CERTIFICATE OF APPROPRIATENESS

Property: 7523 Rockhill Street, Lot 30, Block 67, Glenbrook Valley Sec. 7 Extn Neighborhood Subdivision. The property includes a historic 1,867 square foot, one-story brick veneer single-family residence and attached garage situated on a 8,625 square foot (75' x 115') interior lot.

Proposal: Alteration: Windows

Current Photos Provided By Staff

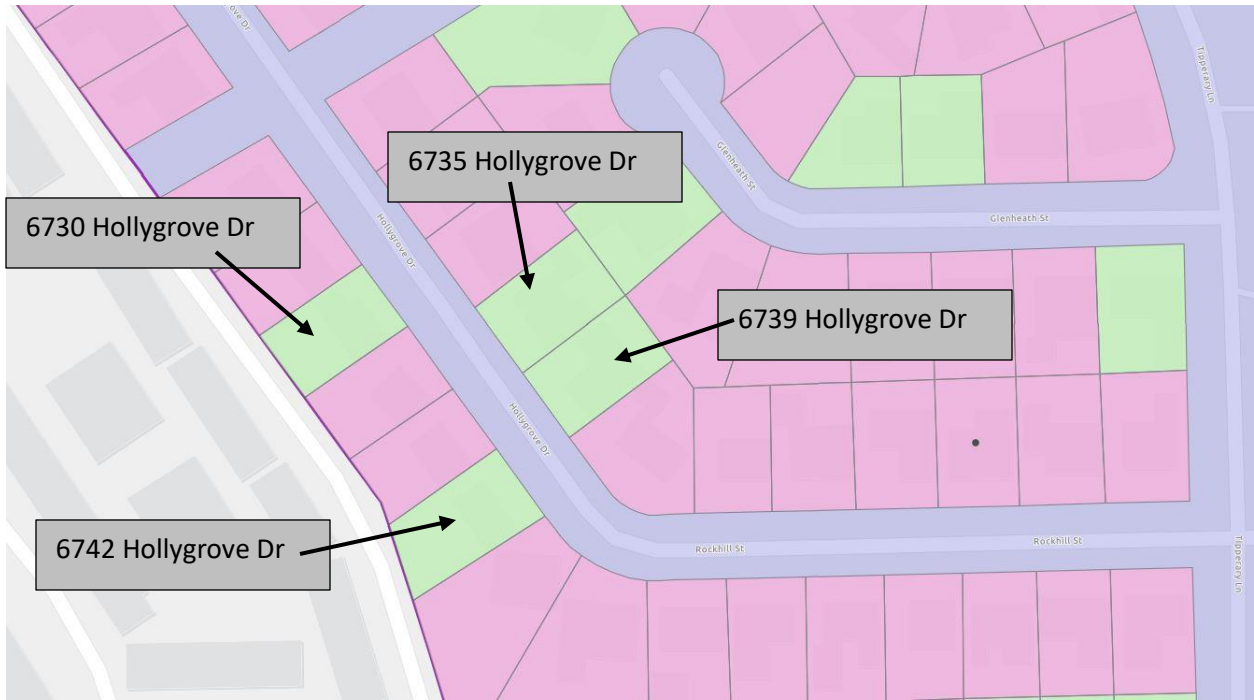
Recommendation: Denial - does not satisfy criteria **Denial of COA. Issuance of COR for work completed and the condition that surface mounted muntins of same shape be placed on the four windows on front elevation where the diamond pattern simulated divided lite pattern appears.**

| <input type="checkbox"/> | <input checked="" type="checkbox"/> | <input type="checkbox"/> | (6) New materials to be used for any exterior feature excluding what is visible from public alleys must be visually compatible with, but not necessarily the same as, the materials being replaced in form, design, texture, dimension and scale; The simulated divided lite diamond pattern is incompatible with the 2-over-2 lite pattern of the aluminum windows in the context area. |
